SUBJECT: Operational Report - Lessons Learned, Headquarters, 84th
Engineer Battalion, for Period Ending 30 April 1970

SUBJECT: Operational Report - Lessons Learned, 84th Engineer
Battalion (Construction), for the period ending 30 April 1970
RCS CSFOR-65 (R2)

EGC-OP (30 April 1970) 1st Ind
SUBJECT: Operational Report - Lessons Learned, 84th Engineer Battalion
(Const), Period Ending 30 April 1970.

AVBC-CG (30 April 1970) 2nd Ind
SUBJECT: Operational Report-Lessons Learned, 84th Engineer Battalion
(Construction), Period Ending 30 April 1970

CAUSEWAY

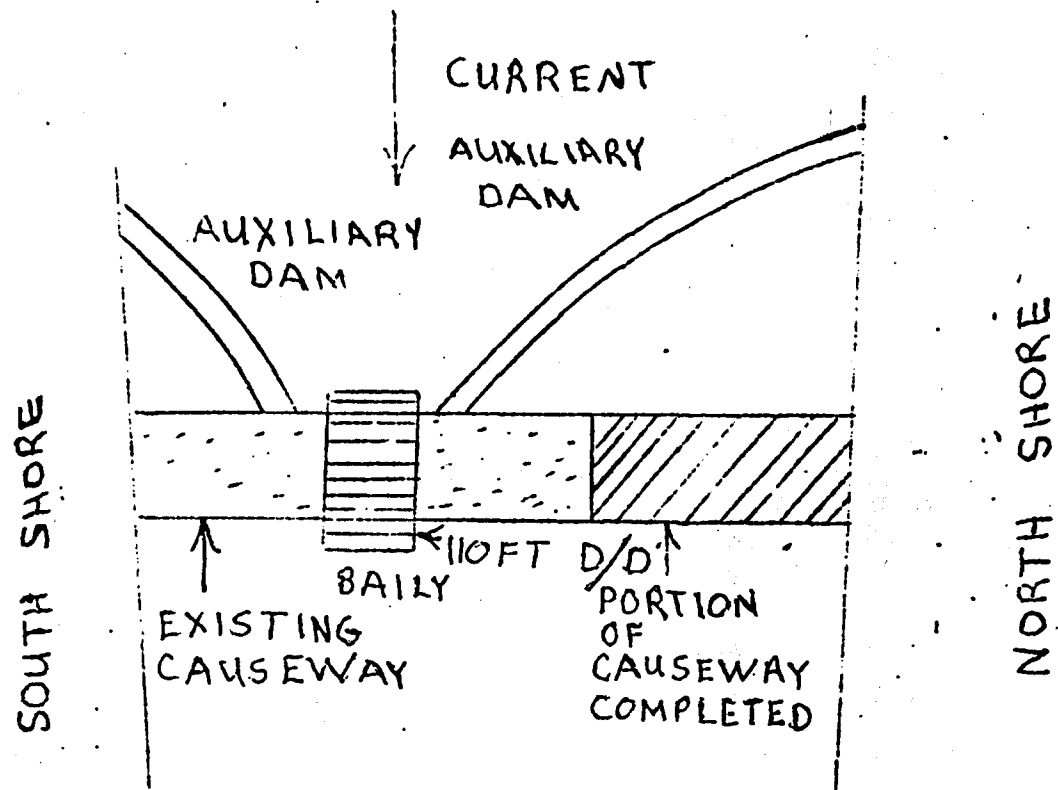
b. Reference: Para 2(b)10. Causeway. A simpler method would be to add blast rock as a rip-rap at ends of the causeway adjacent to stream.
